SUBJECT: MAYPORT DOCKS REDEVELOPMENT PROJECT- REBID

Change Order No. Three (3) Date June 26, 2023

Description of Project Mayport Dock Redevelopment

MAYPORT DOCKS REDEVELOPMENT CO # 03

RSSH	ELECTRICAL SITE PLAN	
						MAYPORT DOCKS REDEVELOPMENT

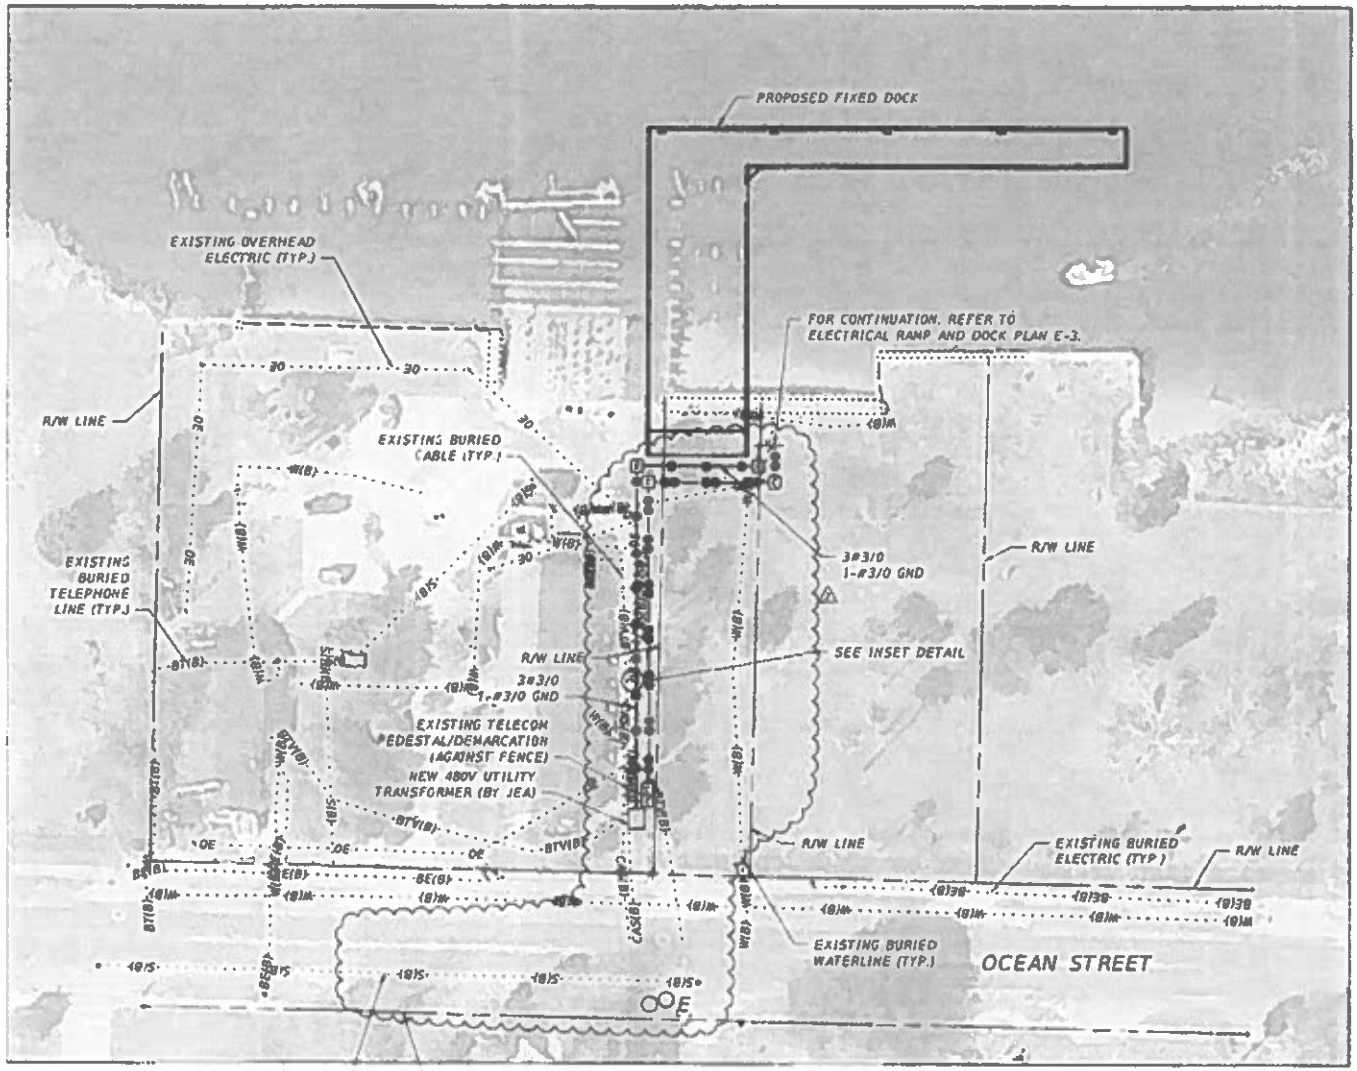
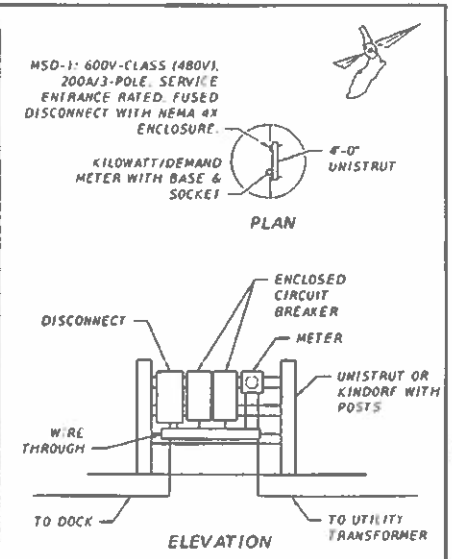
NBR	MASTER ITEM DESCRIPTION	QUANTITY	UOM	UNIT COST	NET DELETION	NET ADDITION
	ADDITONAL SCOPE					
1	Instal ation of New 480V JEA Transformer	1	LS	$ 28.175.00		$28 175.00
	JUSTIFICAT ON: The original plan sheet E-2 showed getting power from a JEA manhole across ocean street to provide power to the dock. The power source in the manhole is 240V where the dock requires 480V. A plan revision was done showing the nstallation of a new JEA 480V transformer on sheet E-2 to be installed and intercept.ng existing conduits to provide power to the dock.					
2	Transformer Cost	1	LS	$7,310.64		$7,310.64
	JUSTIFICATION: Difference between the allowance of $8,145.55 and the actual cost of $14 502 63			$6,357.08		
	TIME EXTENSION					
4	Zero additional calendars days	1		$0.00		$0 00
	No additional time is being requested with this change order.					
	TOTAL ADDITIONAL SCOPE					**$35,485.64**
	SUBTOTAL CHANGE ORDER NO. 1					**35485.642**

The following proposal will cover the necessary work to install a new transformer to provide 480V power to the new dock structure located at 4638 Ocean Street.

1. Work performed at straight time during scheduled working hours.
2. Price based on installation per revised drawing E-2 transformer location.

Will try and get something to you today.
Expectation is your contactor would intercept the existing 4" primary condult and turn up into a new transformer pad supplied by JEA.
JEA removes one primary cable span to transformer 4630 for your contractors work and then repulls into the new pad once work is accepted and sets transformer for the service.

Day 1) The first mobilization to open the ground and locate the conduit location will be three guys and we will have a *mini excavator* and *shovels*.
Safe off and coordinate JEA. (Estimated 4-6' deep)

(Day 2 and 3 when JEA is scheduled) The second mobilization of four men, a mini excavator and tamper will be coordinated with JEA to identify the conduit they would like us to use and then have them de-terminate and remove the cable from the existing primary conduit. At that time we will open the area up enough to install the required JEA provided long radius elbows on the existing conduit coming from each direction (feed and existing transformer). After the primary conduit sweeps have been installed we will backfill and tamp the area in lifts until we reach the depth for our secondary conduits. Installation of secondary conduit stub outs from the transformer pad will be done.

(Day 4) Install grounding and prep pad location to allow setting of JEA provide transformer pad per JEA Rules and Regulations detail 4.03A. Set transformer pad with *crane truck.*

(Day 4 and 5) Installation of bollards per JEA Rules and Regulations detail 4.03C
